**OHIO TURNPIKE AND
INFRASTRUCTURE COMMISSION**

ADDENDUM NO. 1

**PROJECT NO. 59-19-01 (RE-BID)
REPAIRS AND RESURFACING
EASTBOUND AND WESTBOUND ROADWAYS
MILEPOST 8.20 TO MILEPOST 14.80
AND PARTIAL EASTBOUND SHOULDER RECONSTRUCTION
MILEPOST 2.87 TO MILEPOST 8.20
WILLIAMS COUNTY**

MODIFICATIONS TO THE CONTRACT DOCUMENTS

TEMPORARY TRAFFIC CONTROL DETAIL
FOR STAGE 3
BI-DIRECTIONAL ON NEW PAYEMENT

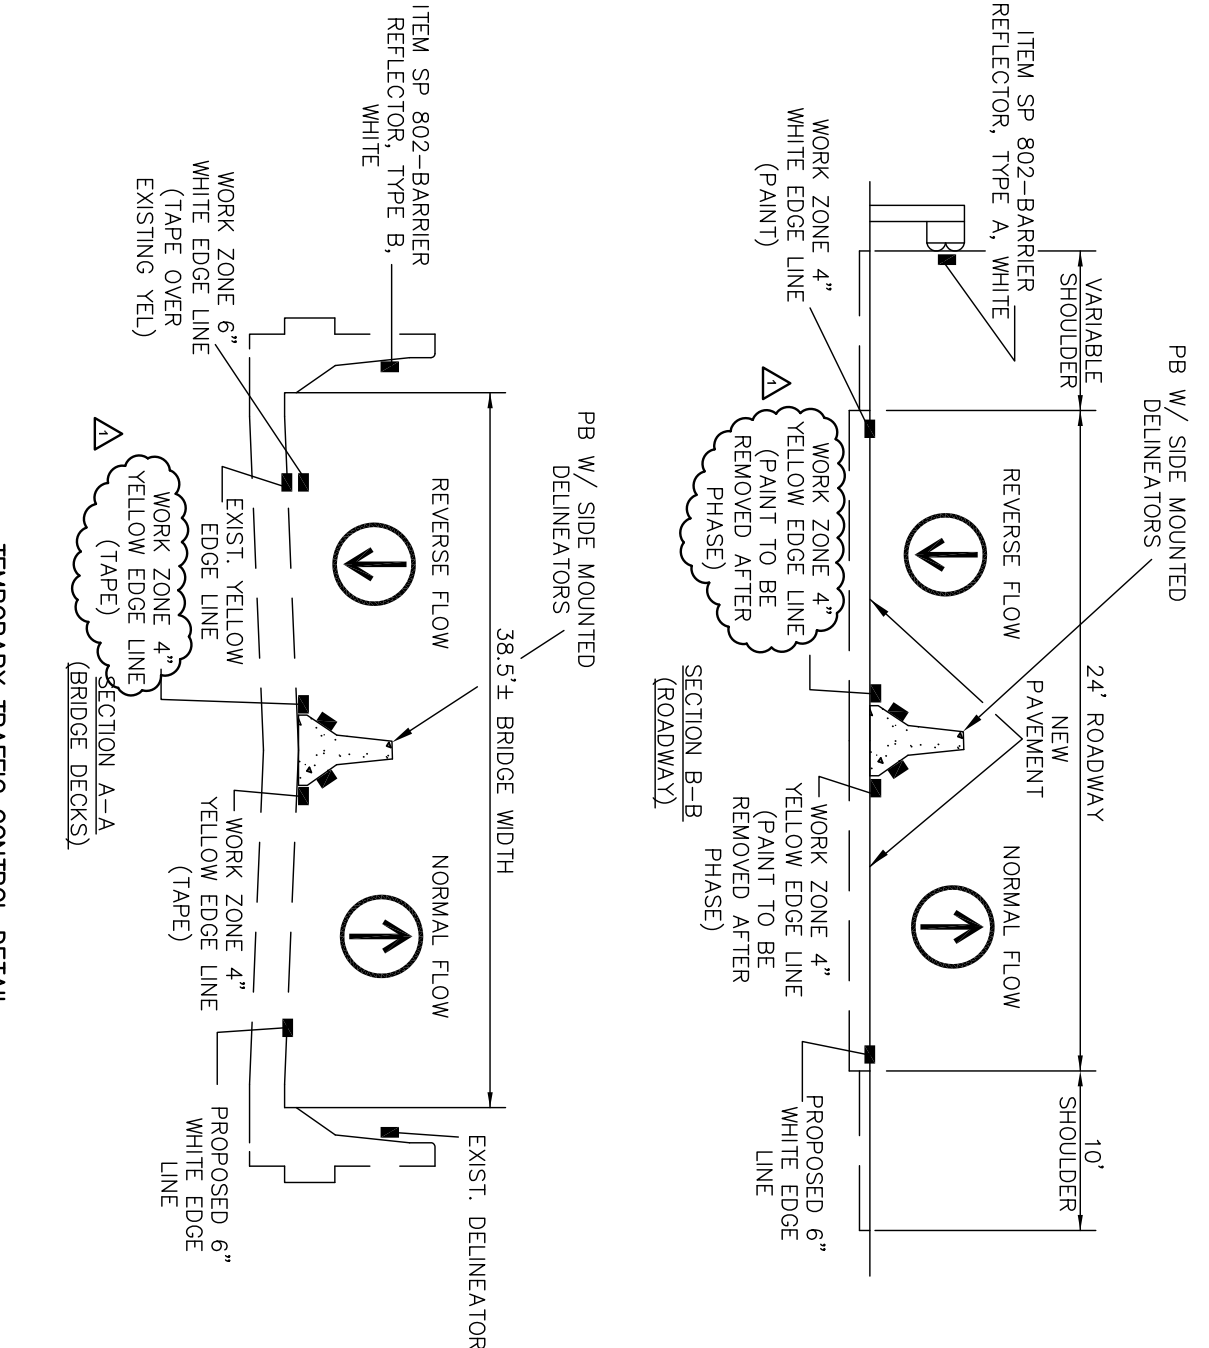
Q#25 On plan sheet 10/14, in both Stages #1 and #3, in the bridge deck sections, the counter flow right side edge line is shown to be taped over, however, note #2 at the bottom of the page requires painting over and hydro-blast removal – which applies? Please note - this taping method has not worked in the past.

Q#26 On plan sheet 10/14, note #1 at the bottom of the sheet states “these sections replace the sections on TCR-3.1.” TCR-3.1 is not included in the plans. Is the entire sheet TCR-3.1 replaced?

Q#30 On plan sheet 10/14, in the notes in the bottom center of the page, note #3 references SP 641C. Is this intended to be SP 614C?

Q#25 Plan Note 2 on Plan Sheet No. 10 of 14 requires the tape method for the bridge decks only. Note 3 limits the removal of temporary pavement markets on resurfaced pavement to hydro-blast demolition.

Q#26 Standard Drawing TCR-3.1 has been replaced with Standard Drawing TCR-4. Plan Sheet No. 10 of 14 is revised accordingly with this Addendum No. 1.

A#30 Yes. Plan Sheet No. 10 of 14 is revised through this Addendum No. 1 to correct the reference to SP 614C.

- 1 -THE ABOVE SECTIONS A-A AND B-B REPLACE THE SECTIONS ON STANDARD DRAWING TCR-4 FOR THIS PROJECT.
- 2 -THE SPECIFIED 6" TEMPORARY WHITE EDGE LINE IS TO BE PLACED OVER THE EXISTING 6" YELLOW EDGE LINE ON EXISTING PAVEMENT ONLY FOR STAGE 1 AND 3. THE SPECIFIED 6" TEMPORARY WHITE EDGE LINE (TAPE) IS TO BE PLACED OVER THE EXISTING 6" YELLOW EDGE LINE ON MAINLINE BRIDGE DECKS ONLY.
- 3 -A QUANTITY OF ITEM SP 614C HAS BEEN ADDED TO THE PLANS FOR REMOVAL OF WORK ZONE PAVEMENT MARKINGS INSTALLED ON NEWLY RESURFACED PAVEMENT. REMOVAL SHALL BE LIMITED TO WATER-BLAST ONLY AND THE CONTRACTOR SHALL DEMONSTRATE REMOVAL METHOD TO INSURE 100% REMOVAL OF LINES AS INDICATED.

MAINTENANCE OF TRAFFIC STAGE(S) 1 AND 3 - DETAILS

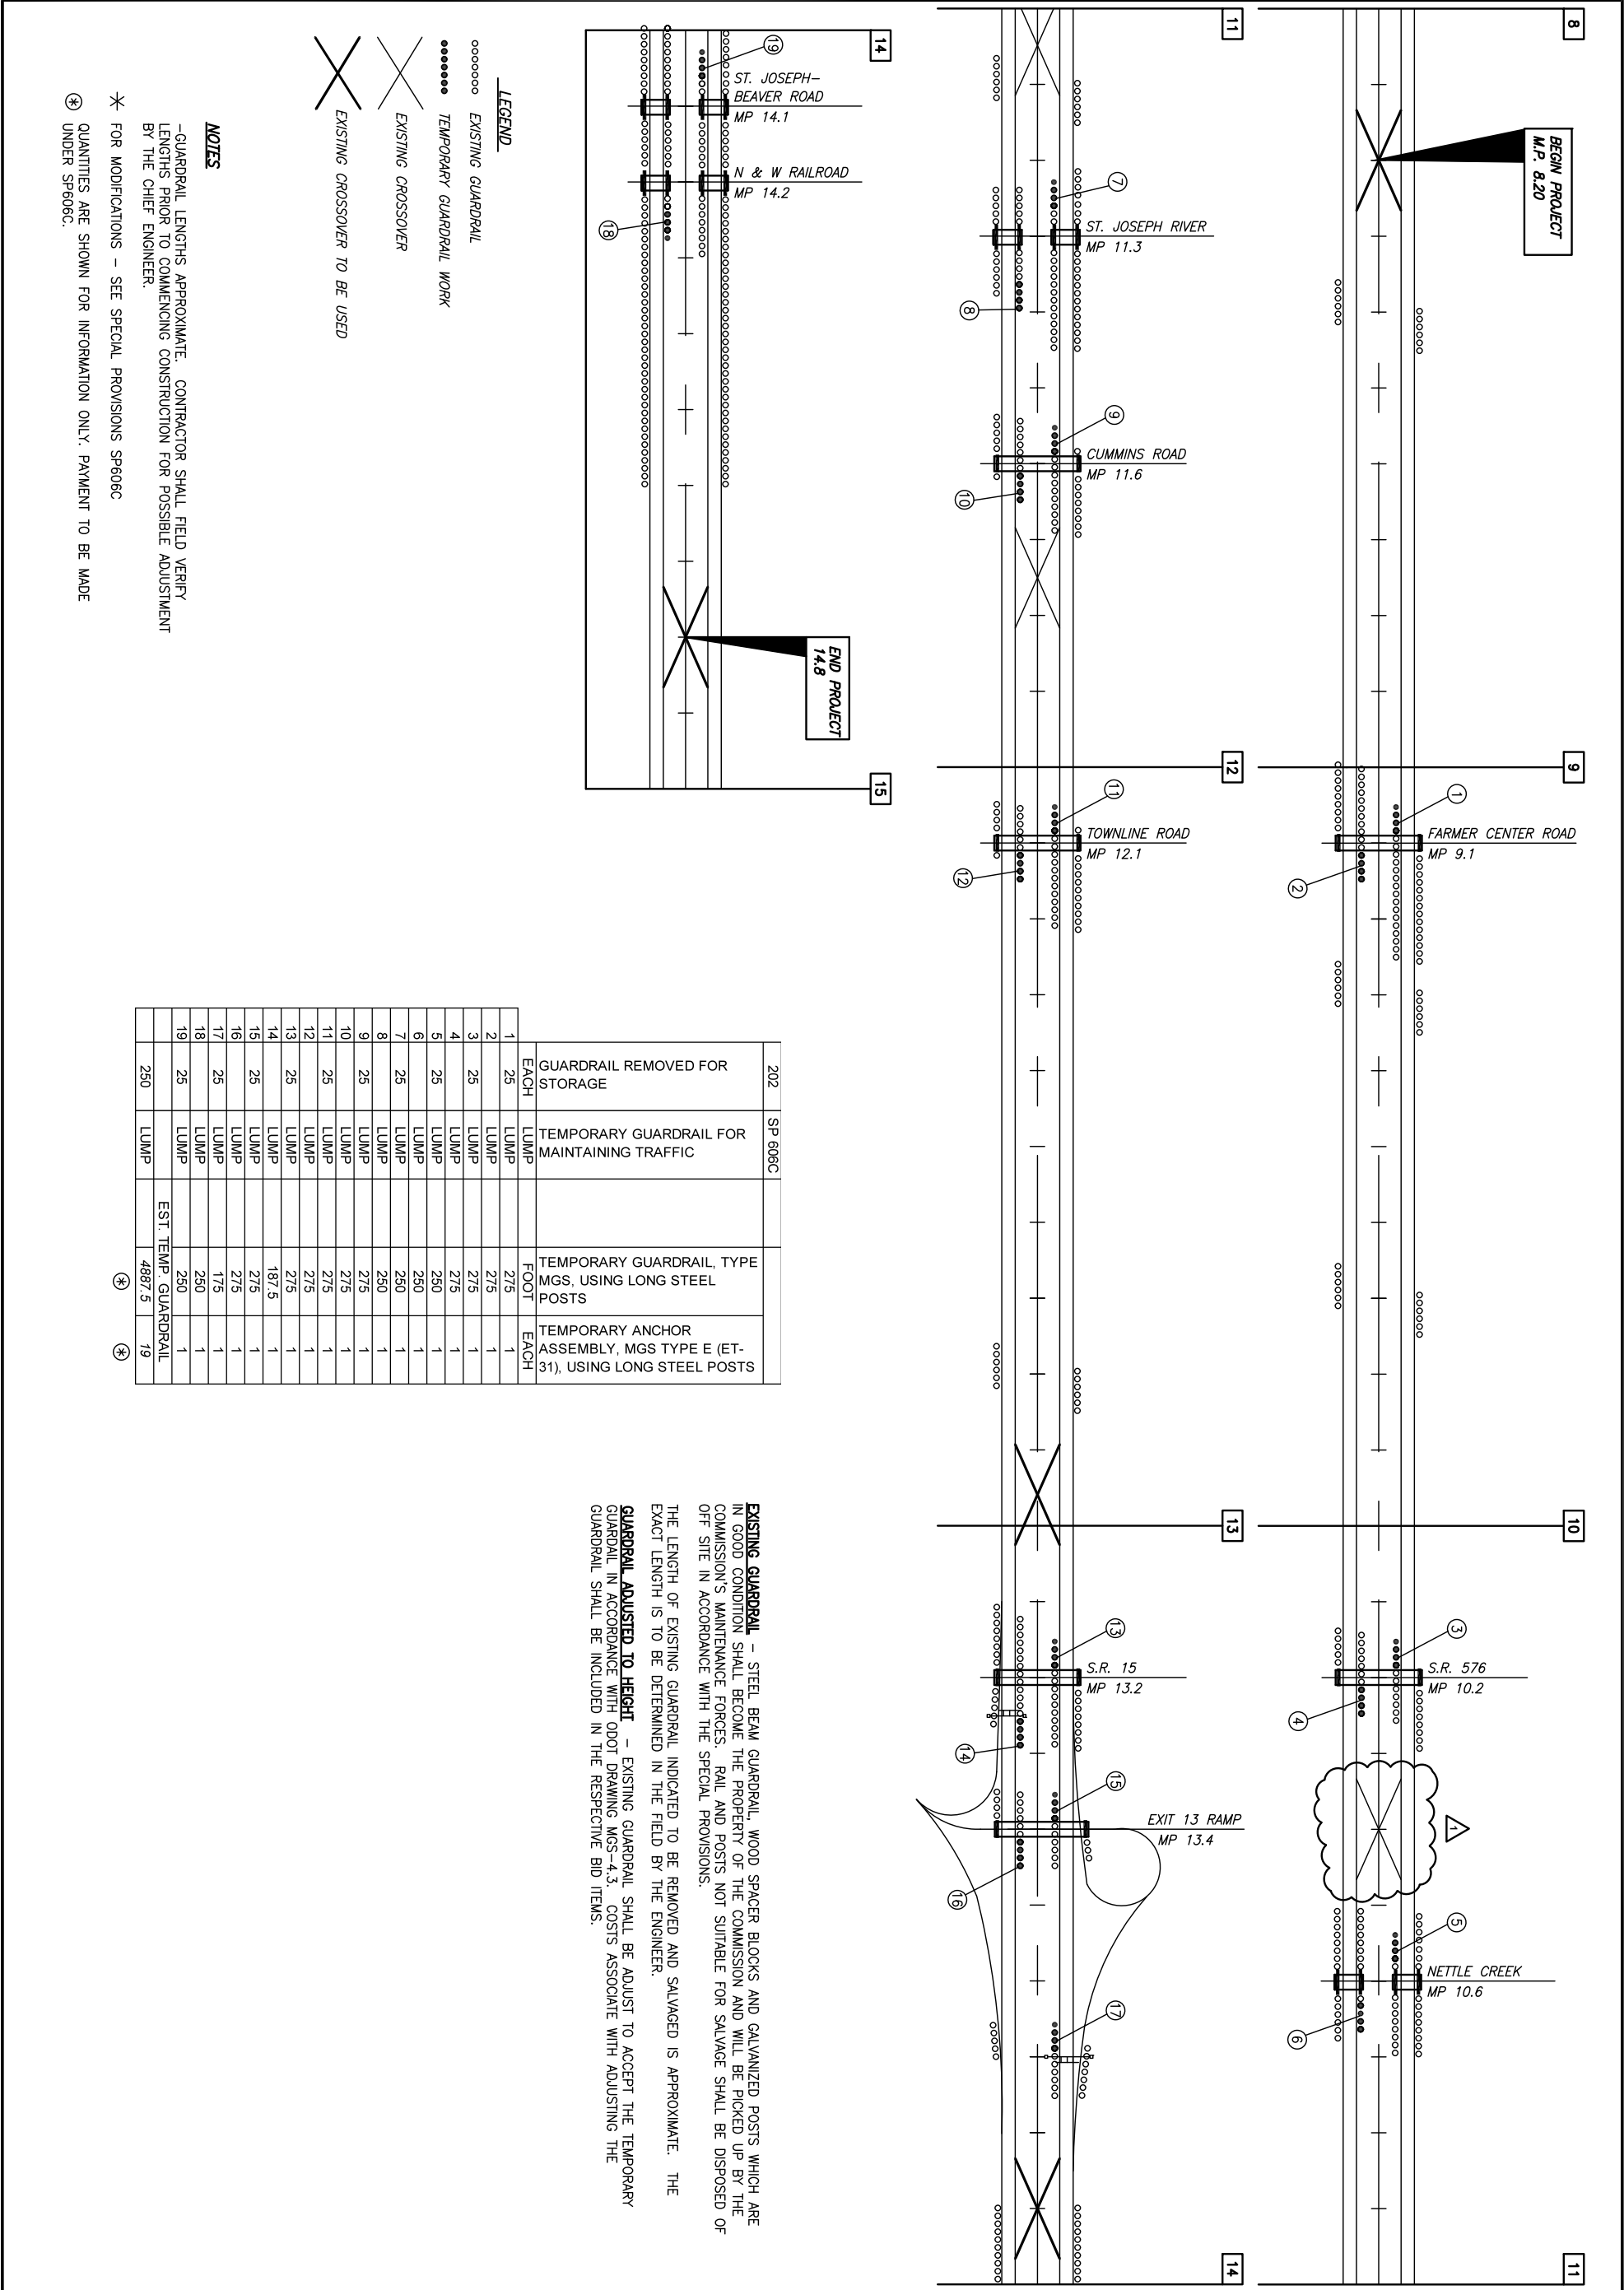
Q#4 On plan sheet #12/14, it appears the high-speed cross-over at MP 10.4 is shown to be used. Can you explain the purpose? Is this intended to be a phase split within stages 1 and 3 requiring portable barrier movement?

A#4 Plan Sheet 12 of 14 is revised through this Addendum No. 1 to show the crossover at MP 10.4 as merely an existing condition and not incorporated or otherwise used under this Project.
